Hydroxide Knitwear Ltd. (Extension)

Mouchak, Kaliakoir, Gazipur, Dhaka
(24.022136, 90.296435)

23 May & 24 July 2023

Building Information

Typical floor loading

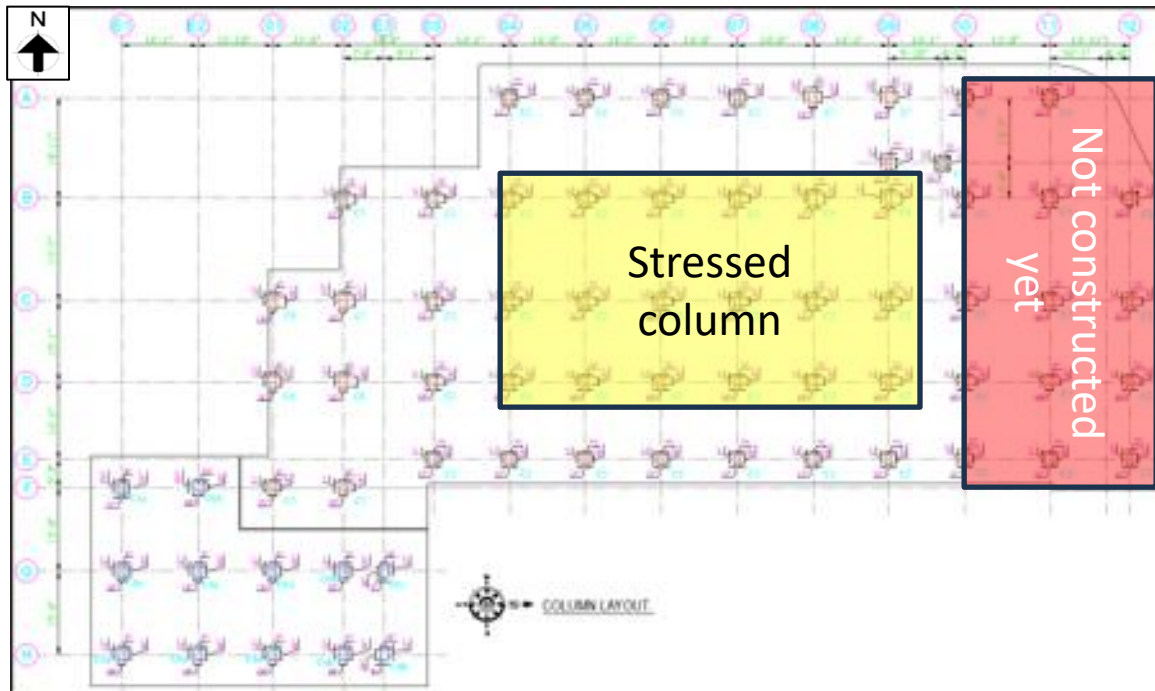
High stressed footing

Cursory calculation indicates that stress exceeds the normal design limit for edge and corner foundation, considering the floor live load 3kPa, minimum concrete strength based on aggregate type and allowable soil bearing capacity 5.33 T/m². Building engineer is required to review the design, loads and foundation stresses.

NORTH ELEVATION

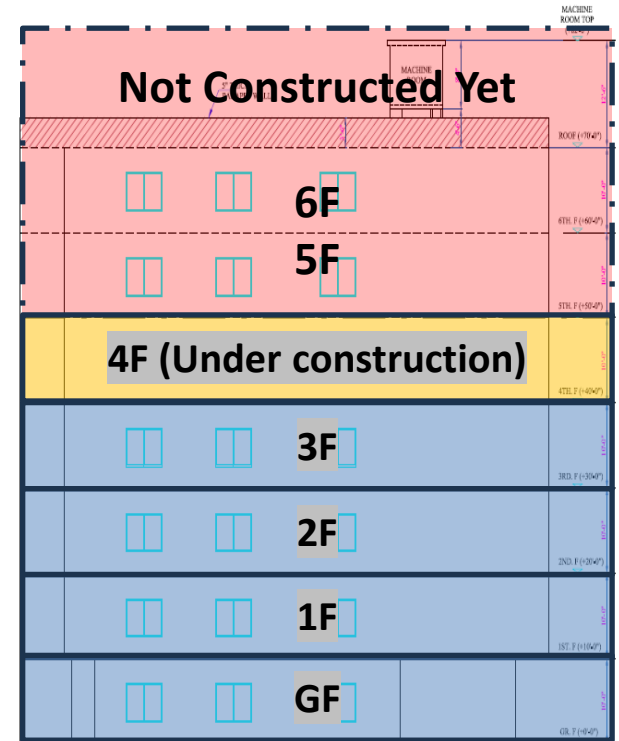
Possible vertical extension

Stressed column/foundation in layout

Cursory calculation indicates the stress in highlighted column in layout will exceed normal design limit for above of 5 storied. Building engineer is required to review, design of column stress in-case of conducting any vertical extension above 5 storied.

Building-6

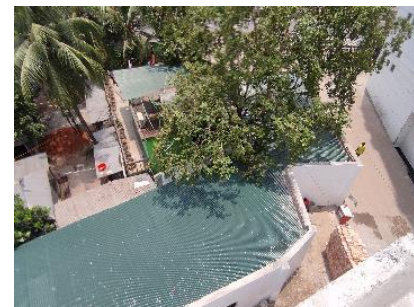
Absence of permit drawing local authority

At the time of inspection, no approval drawing from local authority was available for the above-mentioned structures. Building engineer is required to seek approval from the local authority.
